Massachusetts Department of Transportation

# North Adams Adventure Trail Feasibility Study Protection Avenue to River Street

**DESIGN REVIEW COMMENT AND RESOLUTION FORM**

**Figure 40**—Concept 2, Segment 3

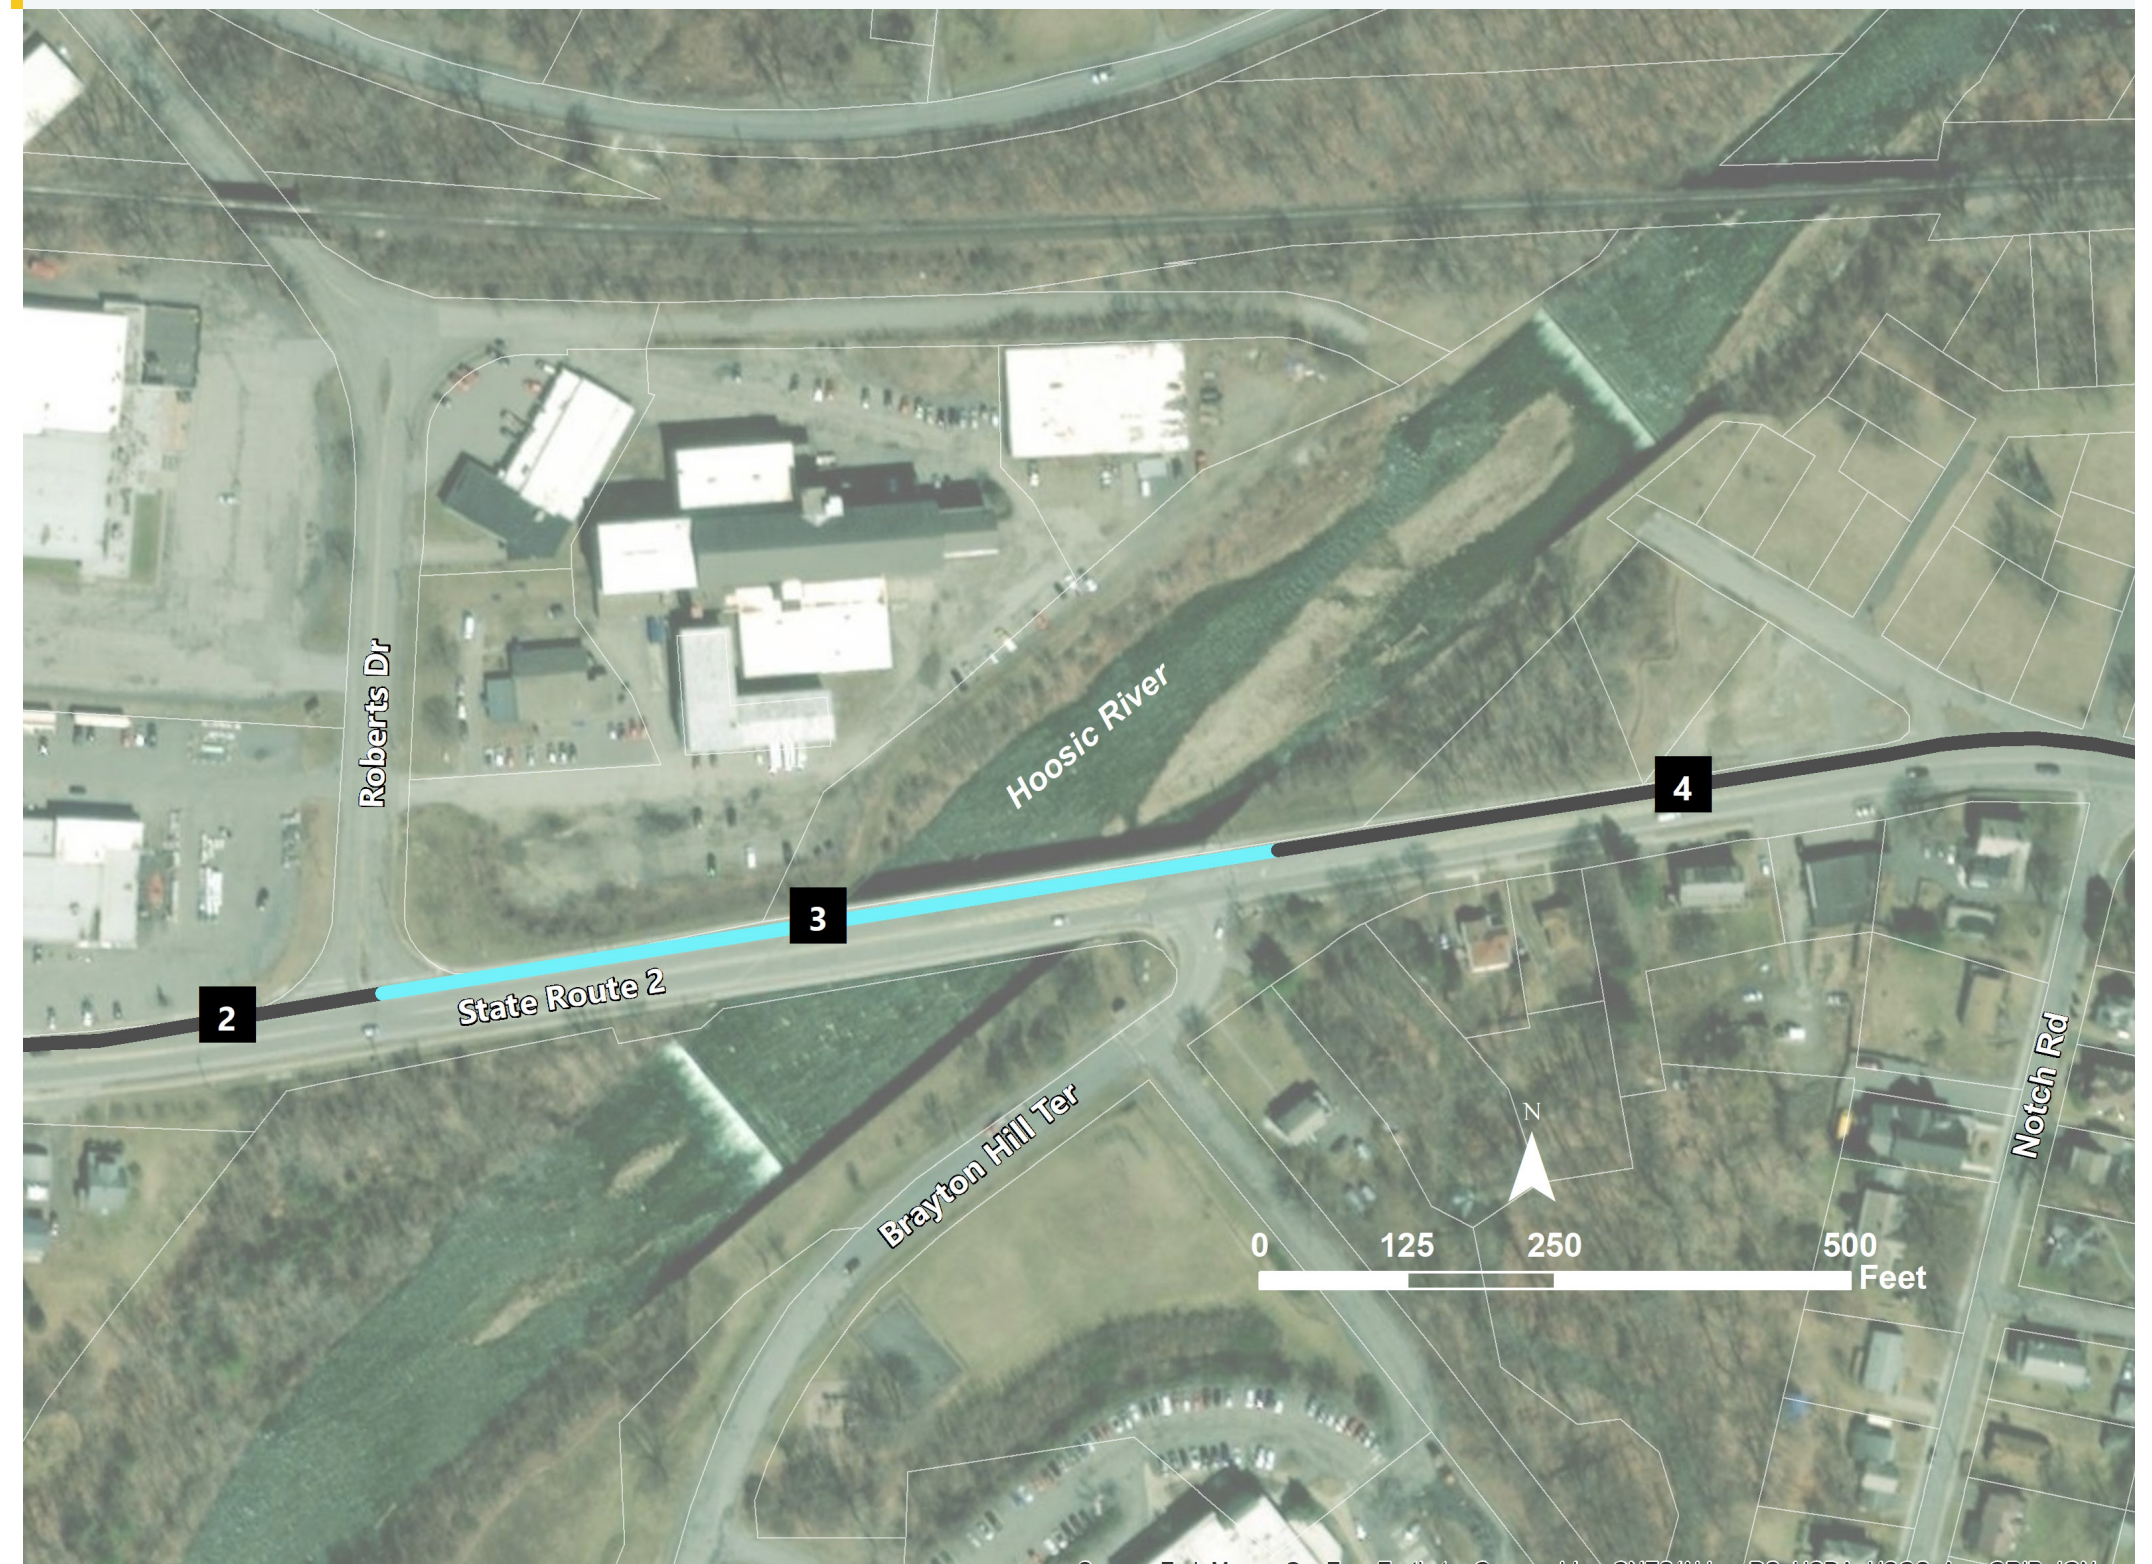
17	34	"...Due to the metal trusses on a portion of the bridge over the Hoosic River, the NAAT alignment will include a constrained width of 7–8 feet using the existing sidewalk adjacent to the truss (see Figure 39). However, MassDOT has identified this bridge for replacement and the design is underway." Highlighted with no additional comment		Assume this is another reference to the challenges associated with narrowing the path to 8' amid strict AASHTO guidelines. We will add additional text that will clarify the coordination with MassDOT bridge team will look into the potential to accommodate a 10' SUP.			Change made
18	45	\$13-14 Million		will add information about cost estimate in document			Change made
19	48	There is little discussion about the AT bridge. The current AT bridge is very narrow and not ADA accessible, while the pedestrian ramps provides some accessibility it is not very wide. I believe it is clear these cannot support the new NAAT, an additional pedestrian bridge would have to be constructed.		will add text acknowledging the existing limitations of the existing AT bridge and the potential to require an entirely separate bridge and how that would impact the option from a cost and impact perspective			Change made

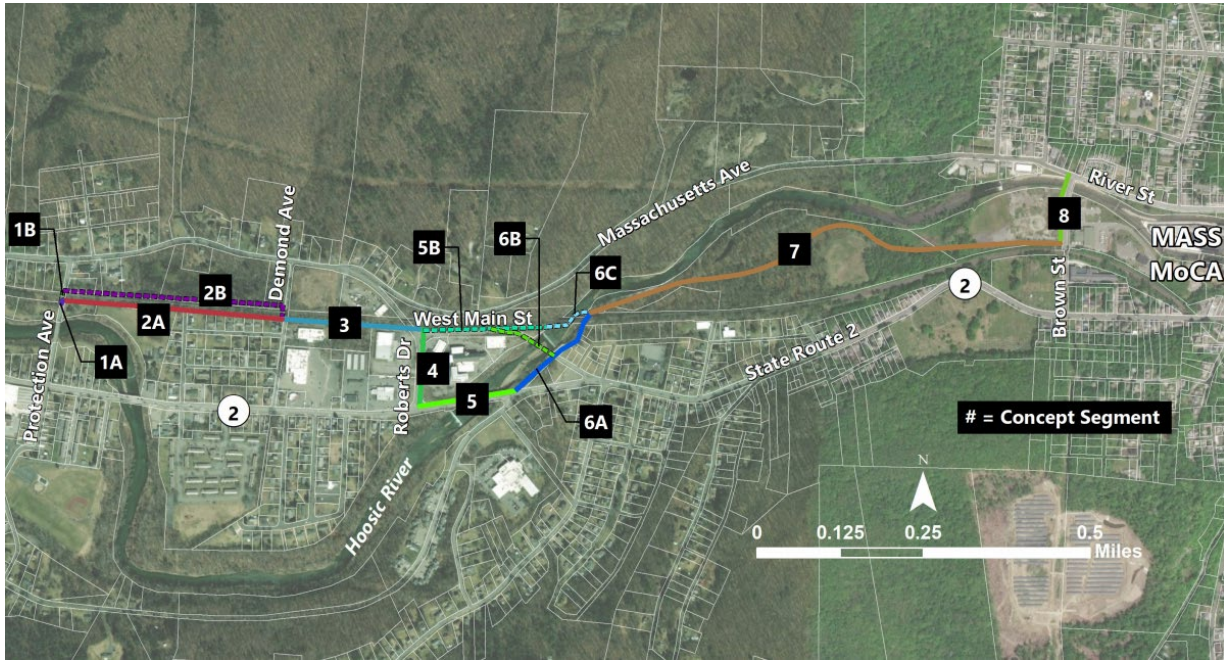
1. Regarding structure, organization, content, etc. OCD has no comment on the study. The study presents three conceptual alignments and various segments thereof, including options for segments where two feasible alignments exist. The only recommendation OCD suggests is to include cost assessments for each of the three concepts, as cost is a significant determinant of feasibility. Comments on each alignment and the segments thereof, including indications for a preferred alignment and segments, are provided in the paragraphs to follow.
2. **Concept 1.** Concept 1, which most closely resembles the original "vision" concept, is OCD's preferred concept. Concept 1, which comprises eight segments with options for segments 2, 5, and 6, is shown below.

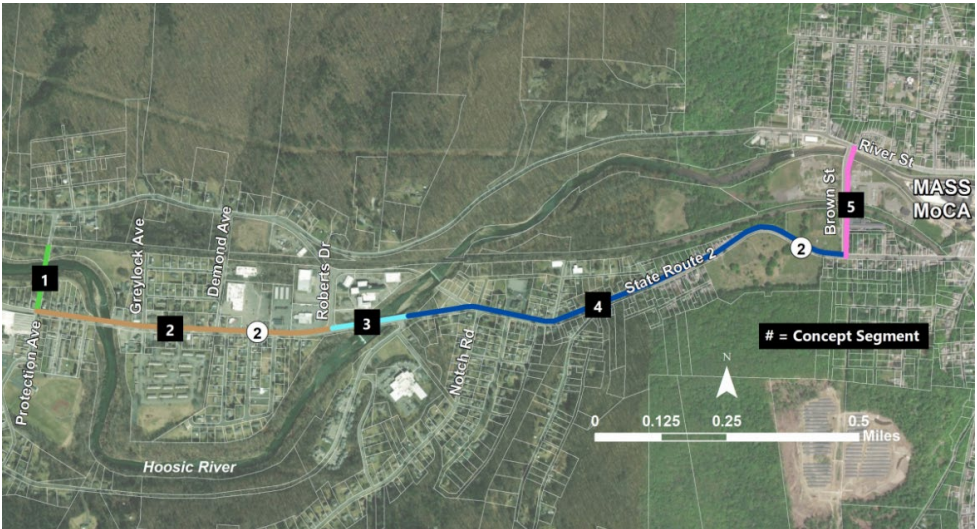
3. **Concept 2.** Concept 2 is OCD's least desirable concept. Concept comprises five segments utilizing existing or expanded public rights-of-way on Protection Avenue, State Route 2, and Brown Street, as shown below:

Concept 2 has been determined undesirable by OCD due to its use of State Route 2 and potential high cost due to the required relocation of utilities and other structures.

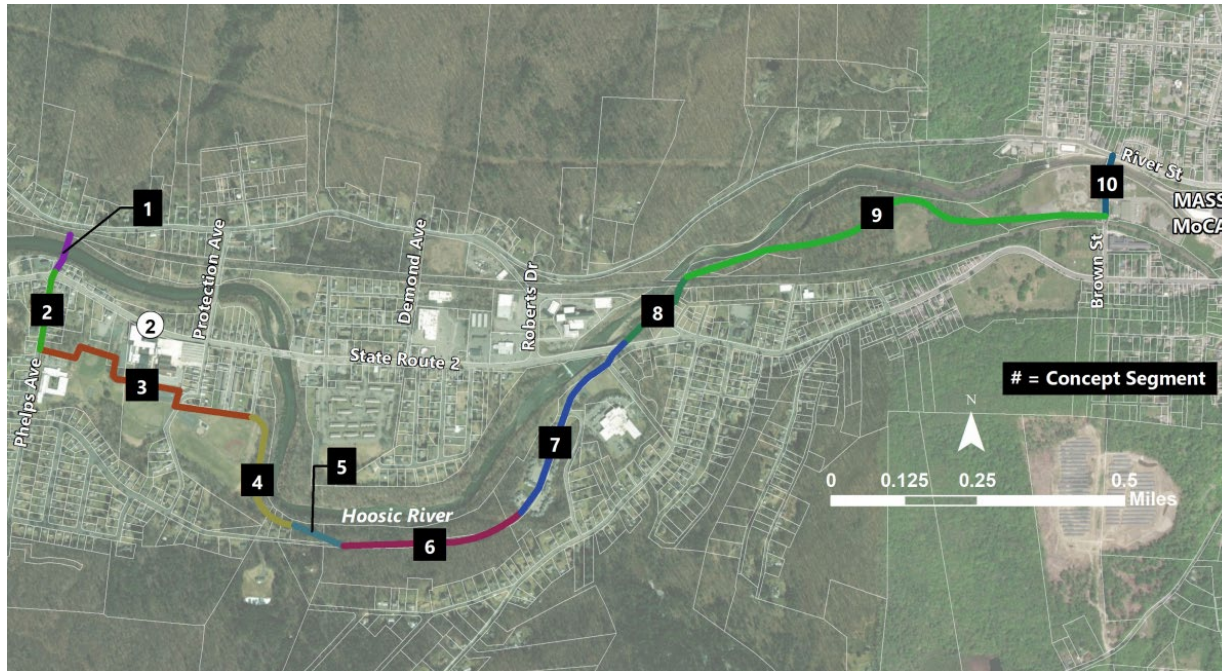
4. **Concept 3.** *Concept 3, while not entirely undesirable, is not preferred.* Concept 3 comprises ten segments and is aligned on the south side of State Route 2, as shown below:

Concept 3 requires crossing of the Hoosic River via a reconstructed Appalachian Trail bridge west of Protection Avenue. The alignment proposed by Concept 3 would then cross State Route 2 and utilized the Phelps Avenue right-of-way before crossing through the Greylock Elementary School (public) campus and the municipally-owned Alcombright Athletic Fields complex via a crossing at Protection Avenue. Concept 3 then follows the path of the Hoosic River before following Barbour Street extension, a paper street, and passing through the Brayton Hill Apartments (affordable housing complex) before crossing State Route 2 and then following the same alignment as Segments 6, 7, and 8 of Concept 1. Despite providing enhanced connection to many public assets and more diverse populations, Concept 3 has been determined undesirable by OCD due to the required reconstruction of the Appalachian Trail bridge, its use of Phelps Avenue and multiple crossings of State Route 2, and its entrance into a neighborhood that has previously demonstrated strong opposition against hosting a bike path.
